NOTICE OF PROPOSED CHANGE IN PROPERTY

Petition: x1388

PETITION NO. 1388
 INTERSECTION CONSULTING GROUP
 500 GRISWOLD AVE.
 DETROIT, MICHIGAN 48239
 C/O BRIAN ELLISON
 PHONE NO. 313 397-5863

Date: March 3, 2017
To: Michael Marks
From: Aaron M. Balch
Subject: DTE Work related to LC Arena Cass Entrance Ramp (City of Detroit Petition 1388)

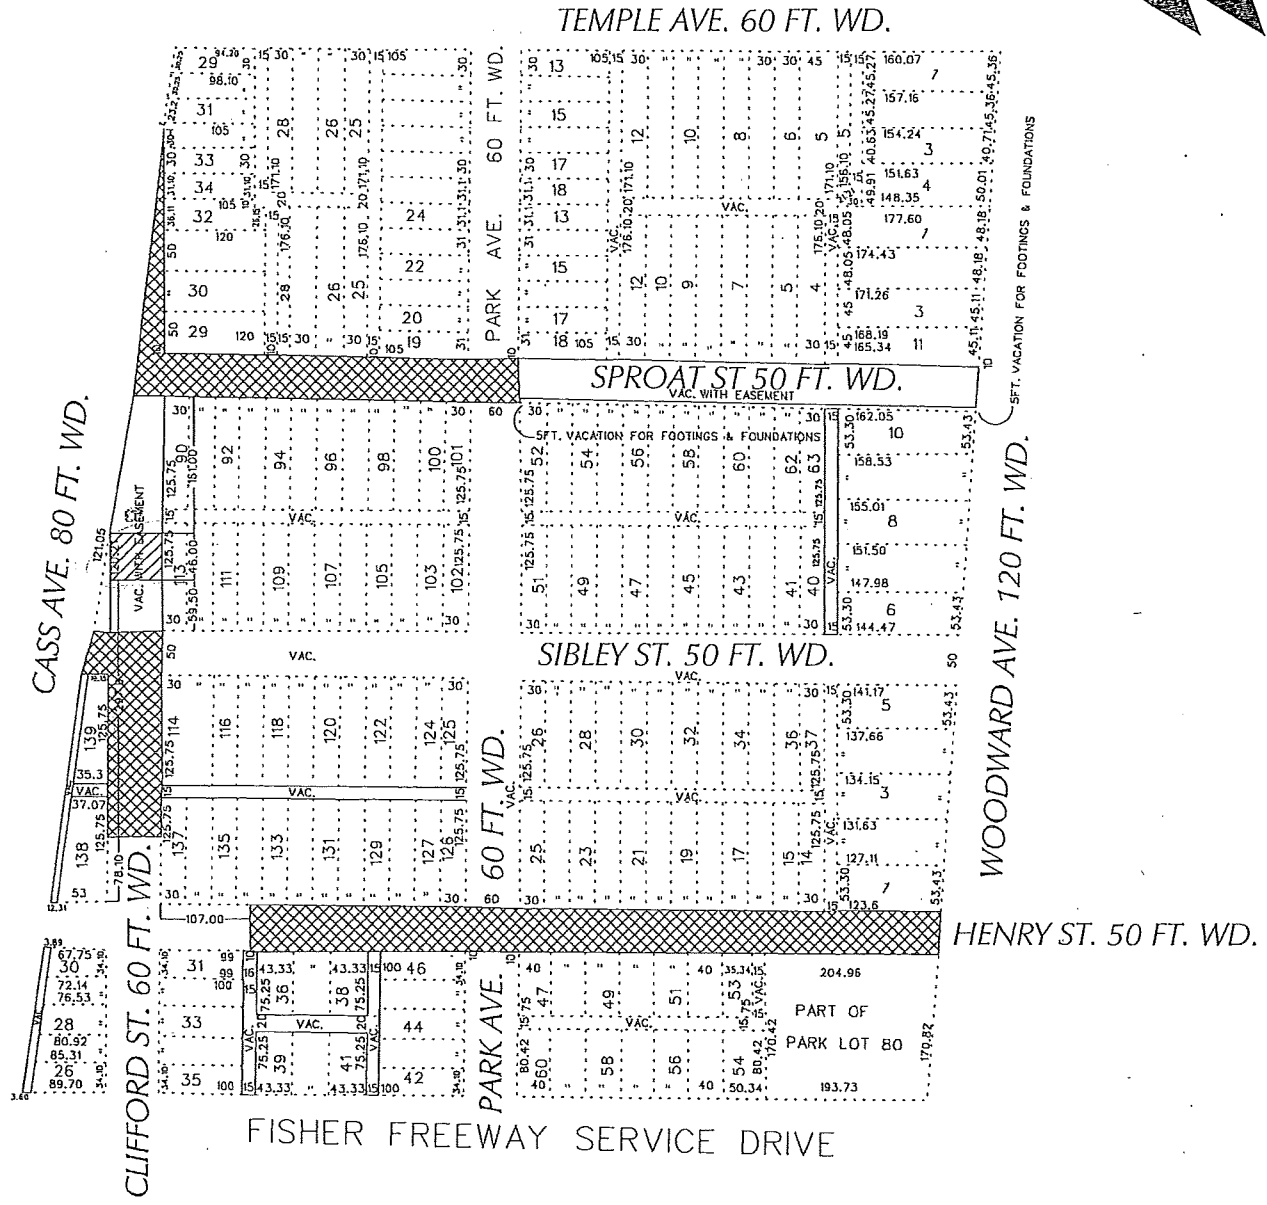
Involved; the nature of our services and the estimated costs of removing and/or rerouting such services are: SEE ATTACHED DOCUMENT

This is a method of service to shore up existing DTE Energy Electric conduit in Clifford St. +/-120' of existing conduit will need to be re-encased to provide adequate support for the proposed excavation and ramp footings to be constructed. DTE will also install (4) additional conduit sleeves the length of excavation prior to re-encasement since future construction will not be possible. DTE also requires dimensioned profiles of future elevations of the proposed ramp and grade relative to DTE infrastructure. Any DTE conduit structure shall not be encased into the footing, but shall have a sufficient geo-foam filled window of 6" around said conduit structure thru the width of the footing. The DTE conduit shall also not be encased into the ramp deck, but shall be maintained at a sufficient depth below said ramp not to exceed a minimum of 6". The resulting depth between DTE conduit and ramp deck shall be engineered fill.

- Install +/-120' of 1x4" 5" PVC conduit sleeves
- Re-encase +/- 120' of
- 40 hours of Underground Technician time

ALL WORK
& PAYMENT
HAS BEEN
COMPLETED TO
DTE SATISFACTION.
PLEASE RECORD
OUR NEW
RESPONSE AS
INVOLVED WITH
NO OBJECTIONS
PROVIDED FULL
WIDTH EASEMENT
IS RESERVED
AMS 7/21/17
